ATTACHMENT A OEH REVIEW OF ISSUES FOR THE CURRAWARRA SOLAR PROJECT

RESPONSE TO SUBMISSIONS (SSD 8437)

From: Mike Whitbread <Mike.Whitbread@res-group.com>
Sent: Thursday, 26 April 2018 11:11 AM
To: Tim Stuckey
Cc: Clay Preshaw
Subject: RE: Currawarra Solar - More Information Request

PROPOSAL LAYOUT AND SITE CONSTRAINTS

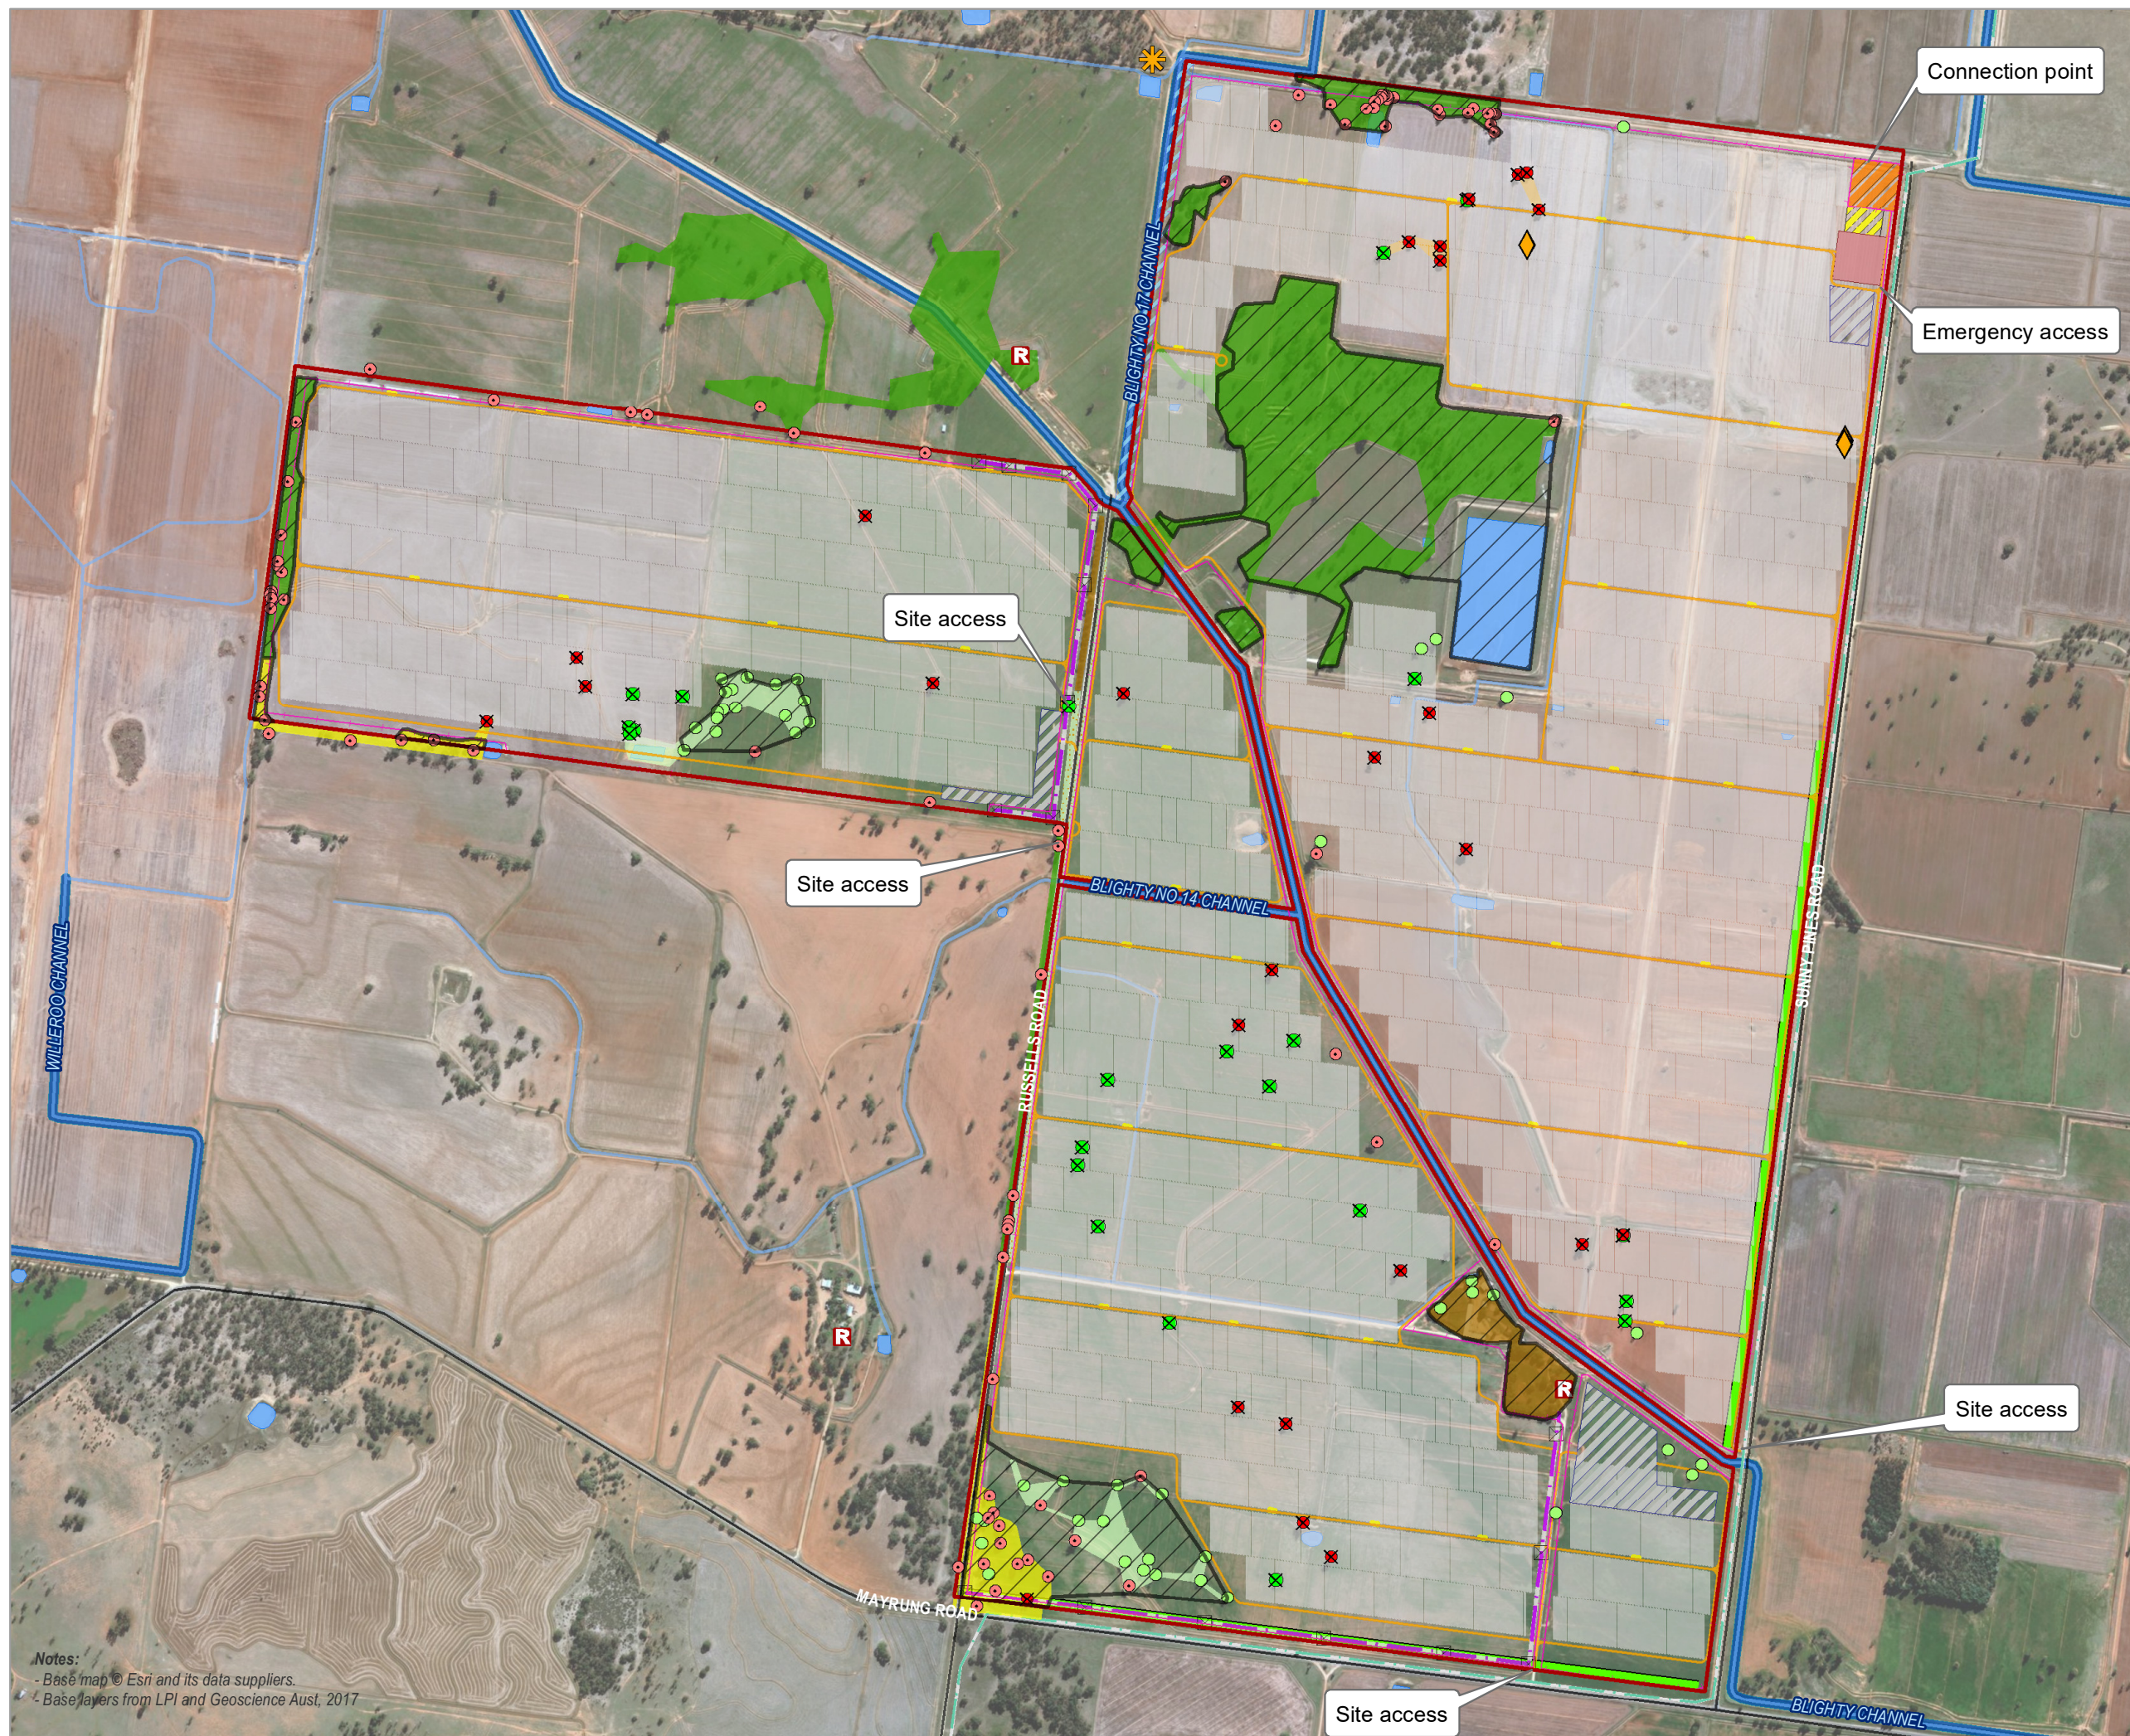
- Revise the main project layout map (Appendix A – RTS) to include the development footprint boundary.
 This plan will follow next week

The revised plan will follow next week due to staff holiday.
